SWIM PROJECT PROFILE

SWIM PROJECT PROFILE		File No. : 1
Regist. No. : Agency No. : DPWH-1	Name: SAYTAN DAM & RESERVOIR SWIP	
Region: 1	Province: LA UNION	Municipality: SAYTAN, PUGO
Present Status: 1. Pre-F/S() ② F/S(1983) ③ D/D(-)		
Purpose: Major : Irrigation Incidental : IF, FG, MH		
Project Feature:

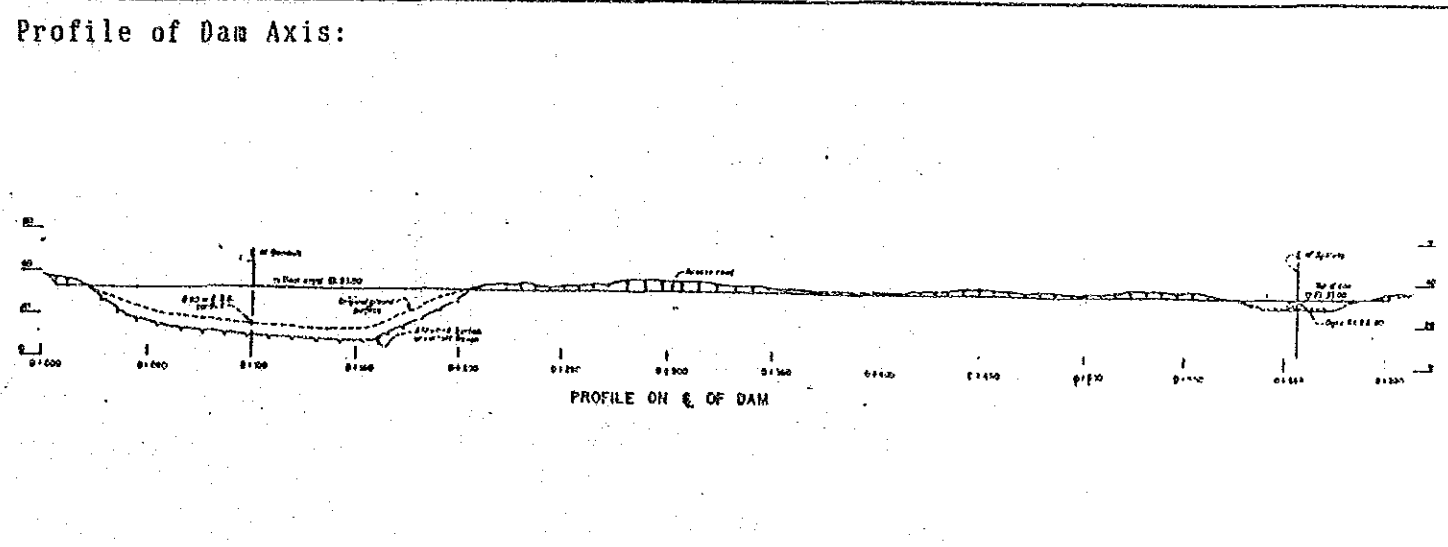
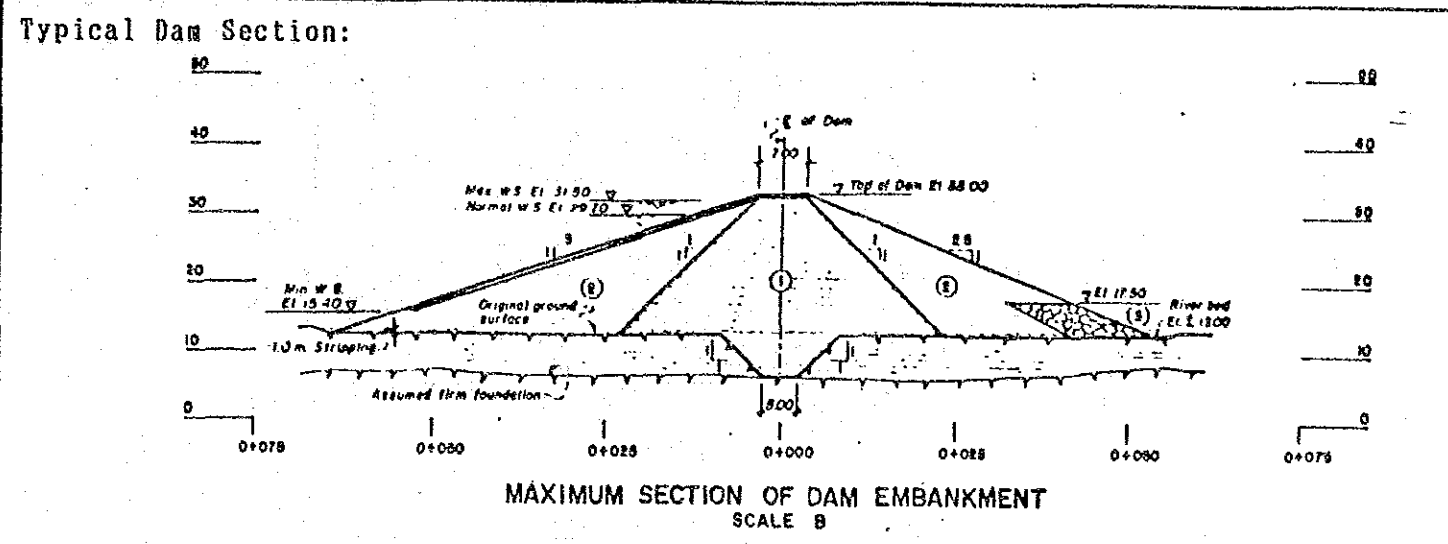
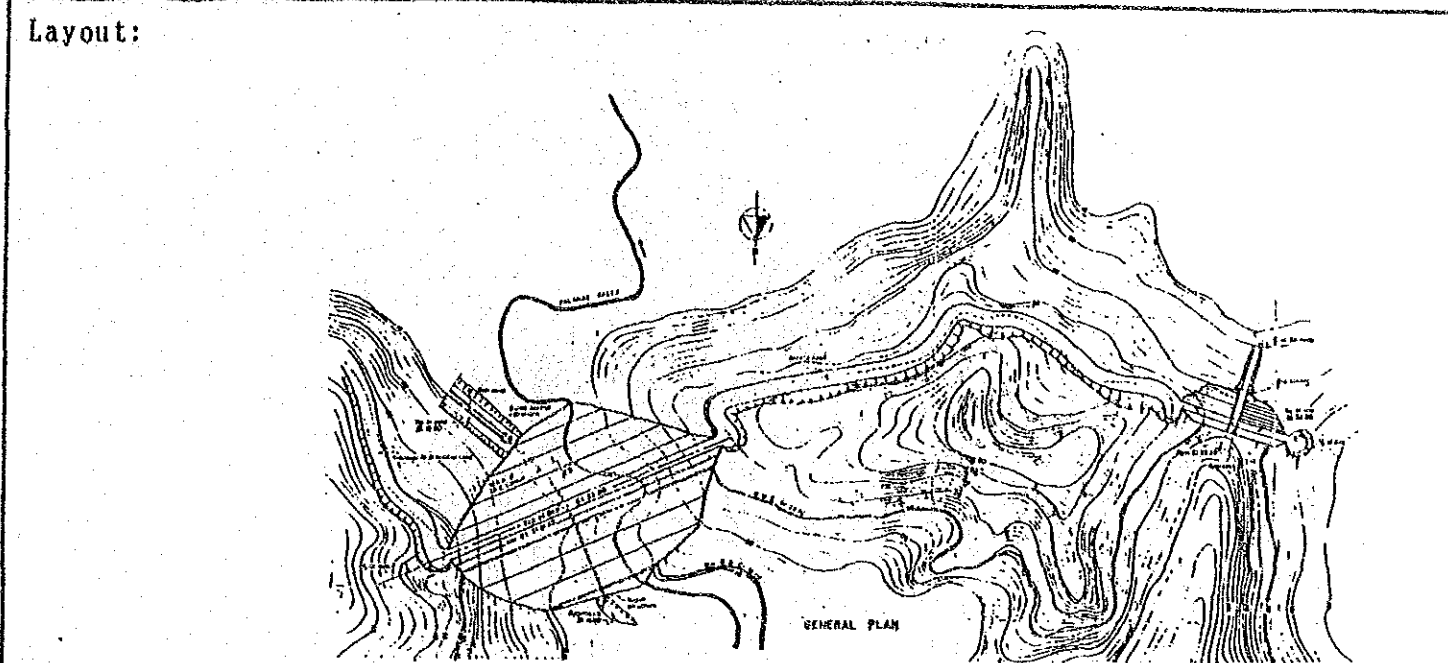
6. Inland Fishery	: Annual Production	: 32 ton/year
Technical Assessment:		
1. Survey and Investigation: Scale of the topographic map for the dam site should be more than 1/500. Soil mechanical test for the dam embankment materials shall be conducted.

2. Planning Agricultural benefit is over-estimated. Environmental conservation plan is not formulated.		
3. Design Permeability of the dam foundation is $1-5 \times 10^{-4}$ cm/sec, but top clay soil act for reducing seepage. Careful compaction is needed near the spillway to prevent the percolation failure. Contact clay shall be laid on the base of core trench. Centerline of conduit of outlet works is recommended to be straight.

Note:
High weathered clay with 2.0 m depth covering the dam site is effective to minimize percolation loss. This foundation has less problem, since river deposits are few.

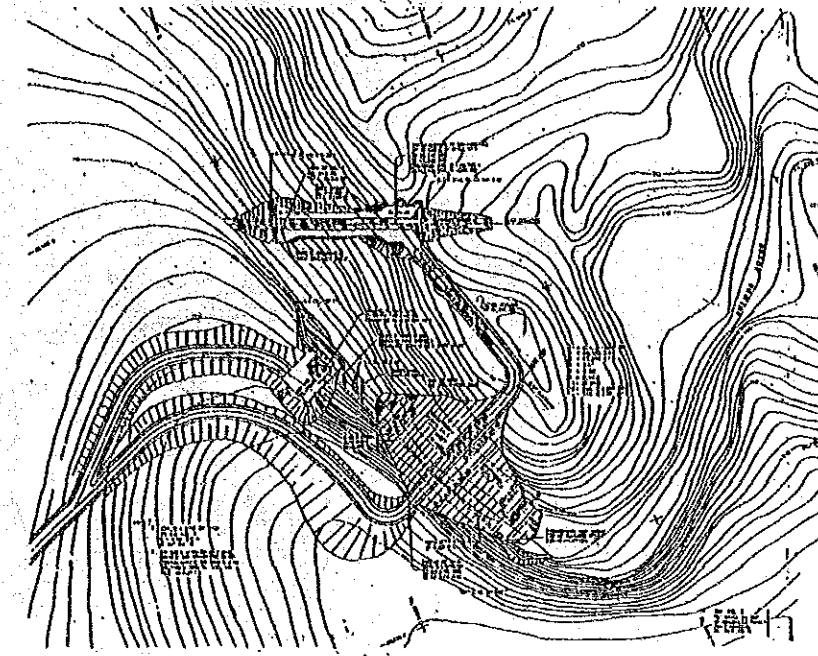
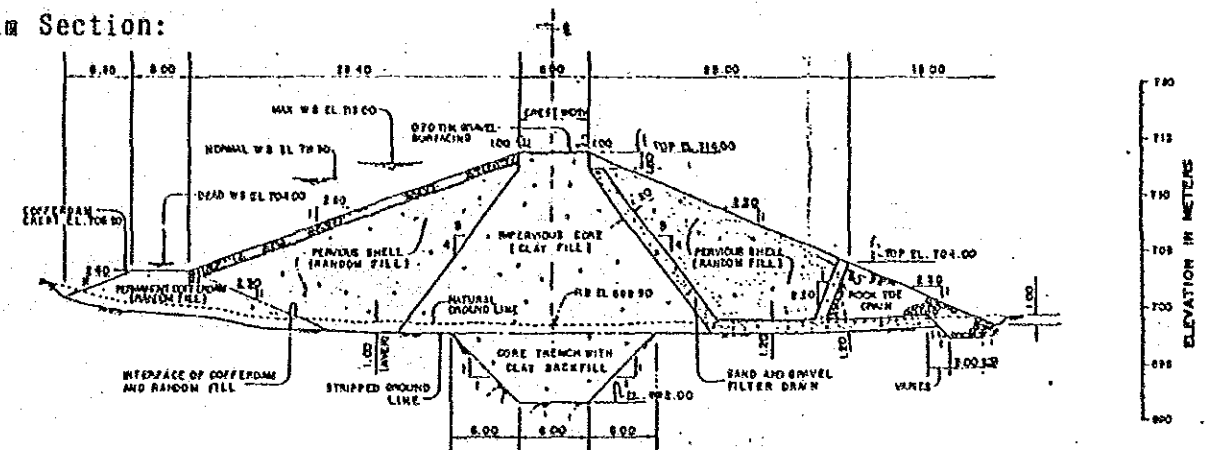
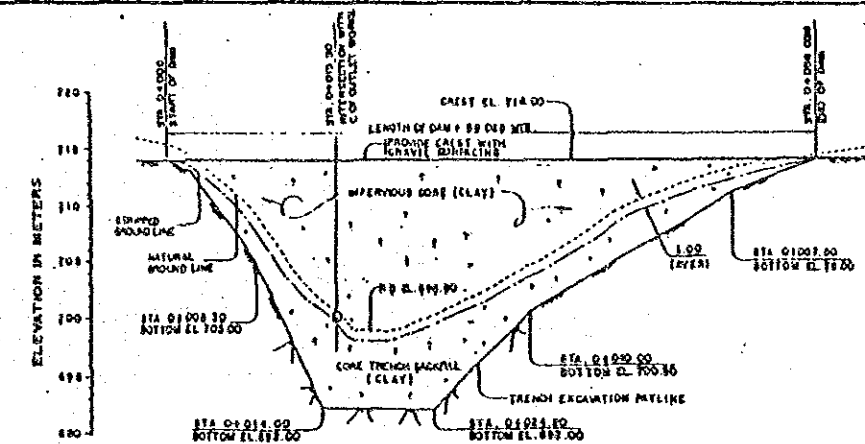
6. Inland Fishery	Annual Production : 19 ton/year	
Technical Assessment:		
1. Survey and Investigation: Drilling survey (Length=20 m) in river bed is essential to observe the bearing capacity and permeability. Top soil with 2.5 m depth can be used for a part of embankment materials. Quarry site of contact clay, filter and concrete's aggregate shall be mentioned.

2. Planning Formulation of irrigation development plan is not mentioned. Scale of mini-hydropower is not reasonable. Mini-hydro. benefit and annual production of inland fishery are over-estimated. Watershed management plan is not formulated.

3. Design Additional boring is necessary in river bed for permeability and N value. Contact clay shall be laid on the base of core trench. Careful compaction is needed near spillway to prevent the percolation failure. Inlet of outlet works is recommended to be located outside of the dam embankment.

High weathered agglomerate and weathered agglomerate in surface layer with 2.5 m depth could be used for embankment materials. Borrow area for contact clay, filter and concrete's aggregate shall be secured.

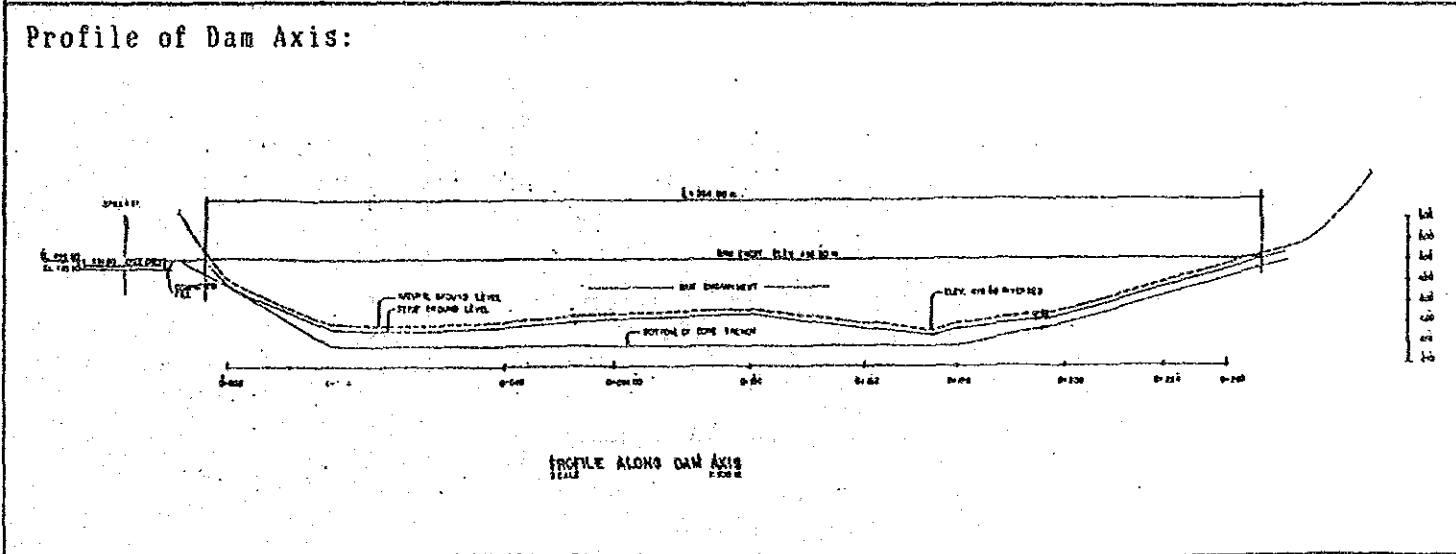
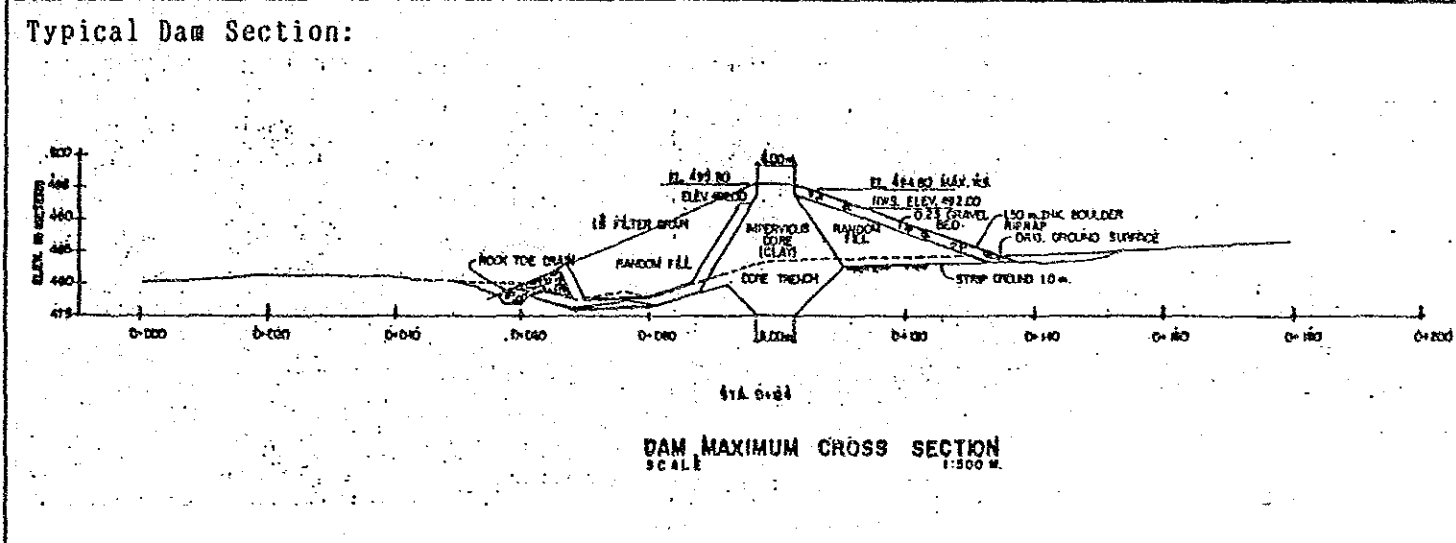
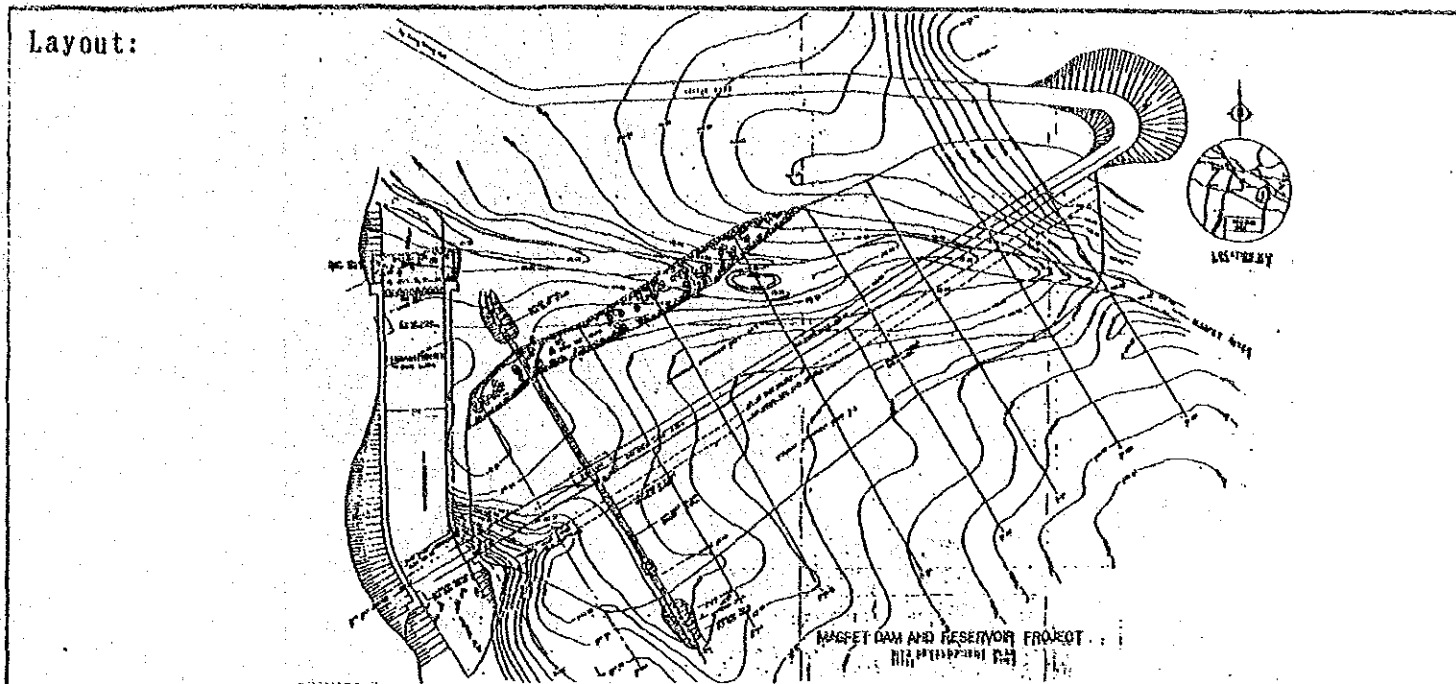
6. Inland Fishery	: Annual Production	: 11 ton/year
Technical Assessment:		
1. Survey and Investigation: Scale of topographic map the dam site should be more than 1/500. Permeability and bearing capacity shall be measured. Soil mechanical test for the dam embankment materials shall be conducted.

2. Planning Agricultural production and annual production of inland fishery are over-estimated. Watershed management plan is not formulated.		
3. Design Permeability and N value in high weathered tuff are necessary for the determination of excavation line. Foundation treatment shall be designed in consideration of the test results. Location of weir in spillway should be shifted to upstream side. Inlet of the outlet works should be located outside of the dam embankment.

Note:
Restudy on excavation line in riverbed are necessary after confirmation of permeability and bearing capacity in high weathered tuff.

LAYOUT OF DAM & APPURTENANT STRUCTURES

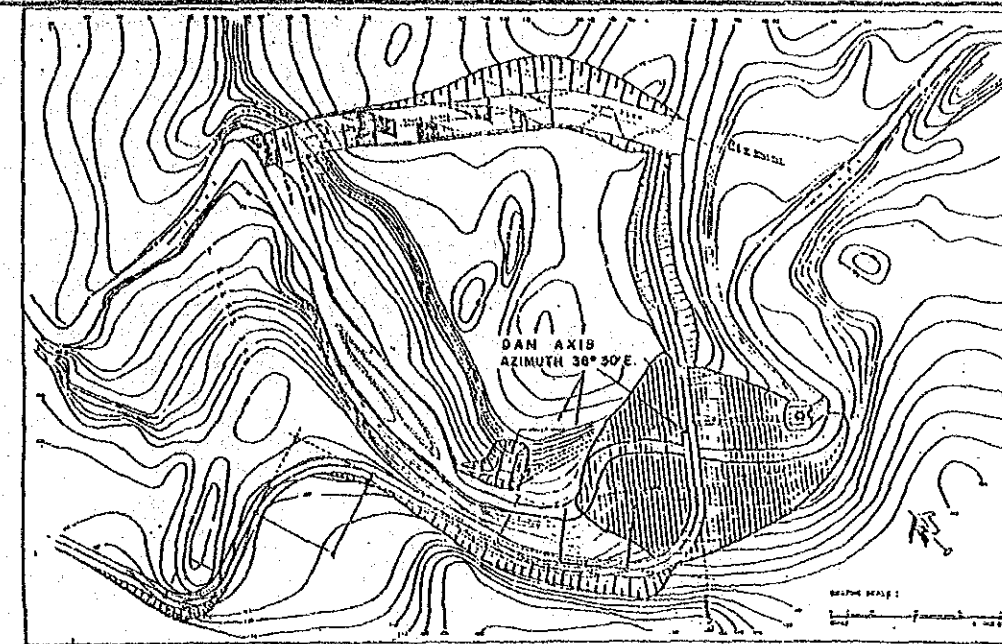
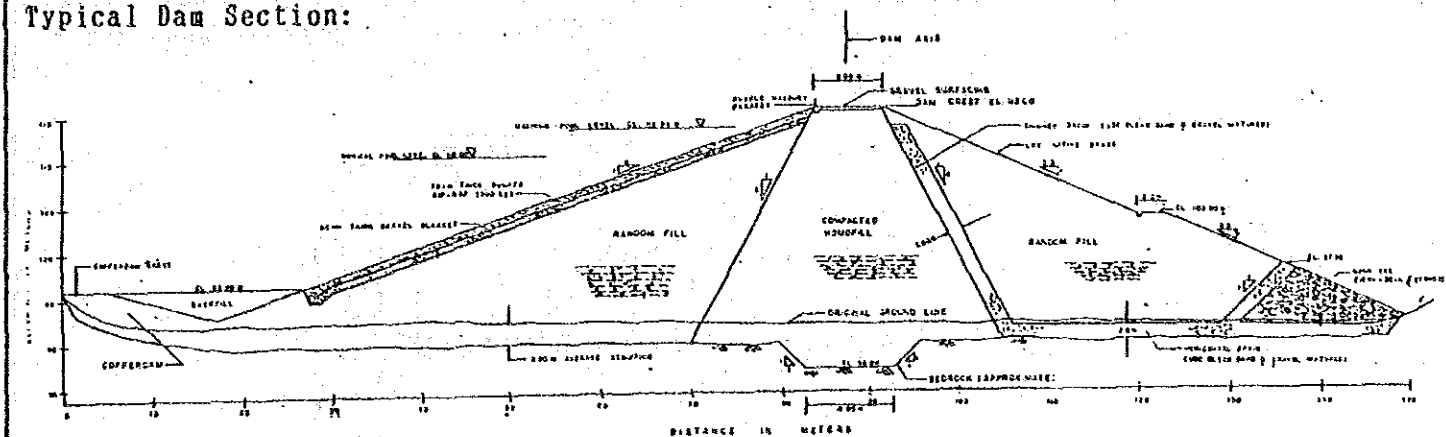
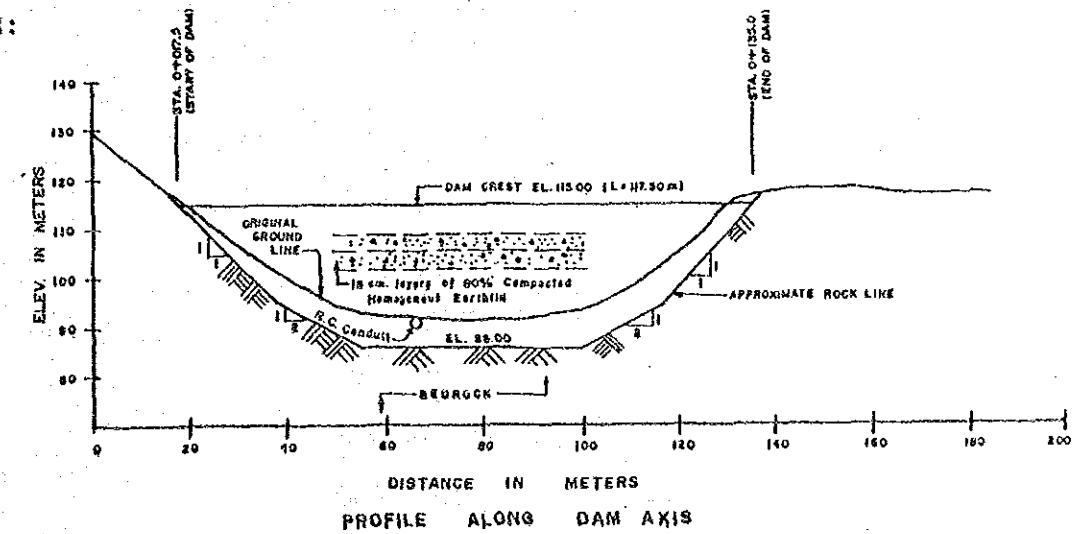
6. Inland Fishery	: Annual Production	: 24 ton/year
Technical Assessment:		
1. Survey and Investigation: Scale of the topographic map for dam site shall be more than 1/500. Bearing capacity should be measured. Permeability test is required for the study of leakage amount, grouting necessity and breadth of core trench. Soil mechanical test for the dam embankment materials shall be conducted.

2. Planning Mini-hydro. benefit is over-estimated. Watershed management plan is not formulated.		
3. Design Supercritical flow section in the spillway should be straight. Inlet of the outlet works shall be located in outside of the dam embankment. Diversion discharge 21.7 cm ³ /sec would be reasonable in the light of the construction period.

The proposed excavation line seems to be deep. It must be studied in D/D stage.

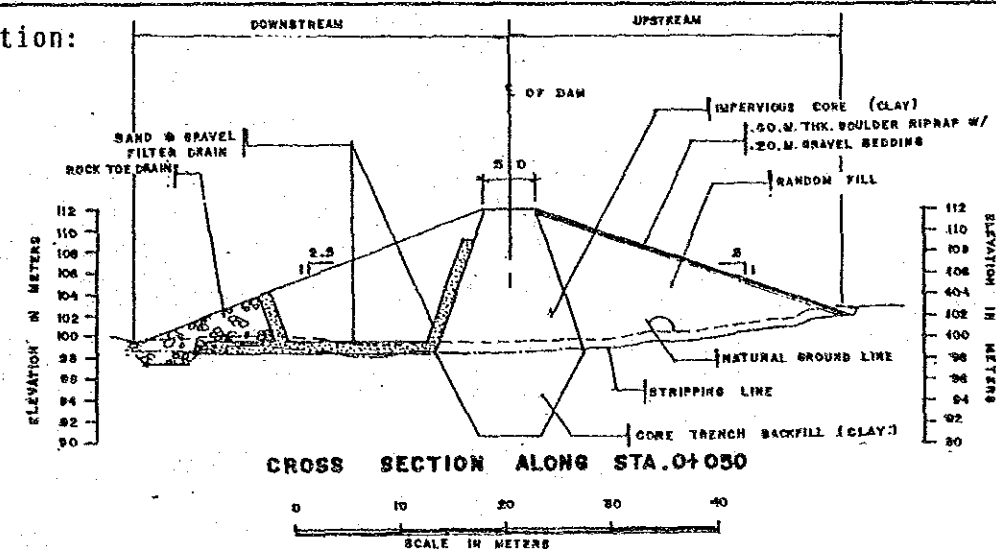
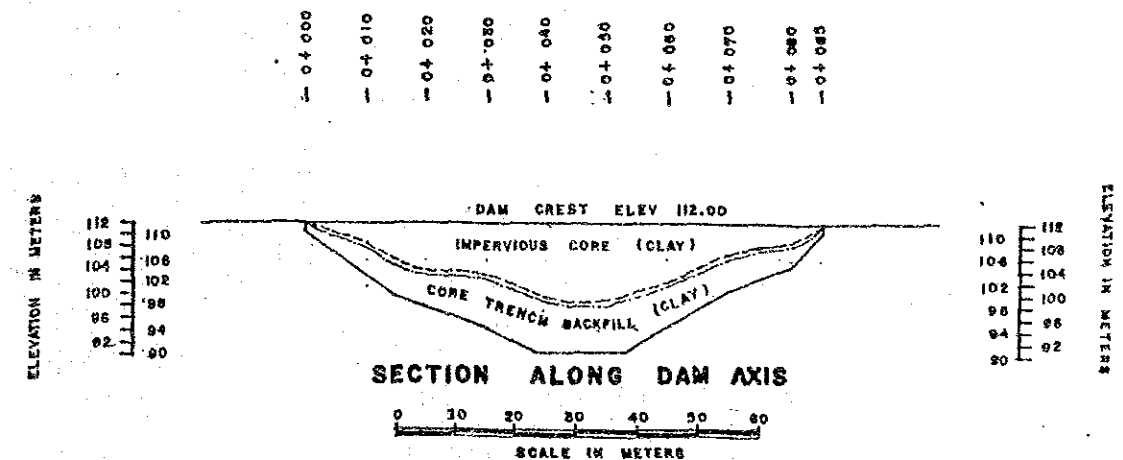
Dam type might be refined through the investigation on materials. Form and depth of core trench shall be decided after sub-surface geological study. If pervious layer is deep, impervious blanket instead of core trench is planned in the upstream.
